Access Compliance Report Public Rights-of-Way (Island Curb Cuts)

Main Street: DORRANCE_DR		Cross Street: DORRANCE_DR		Location:	W
ADA ID: CCRK211110130817	Curb Cut Type: MedianRefuge2	Initial Pass/Fail: Pass	Overall Compliance: No	Severity Score:	15

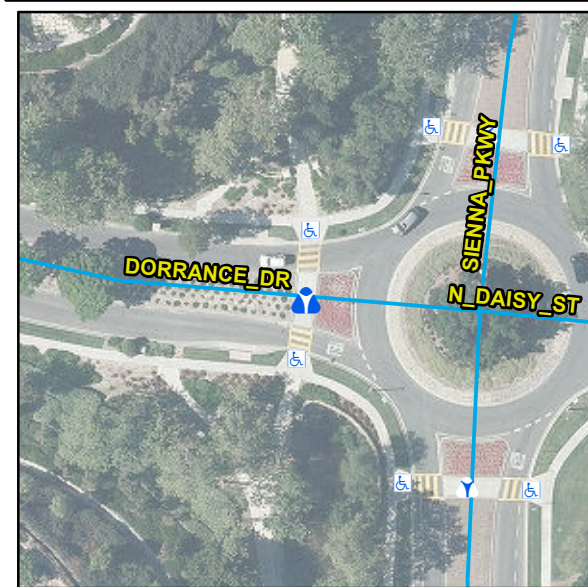
Possible Solutions:

Install Detectable Warning System.
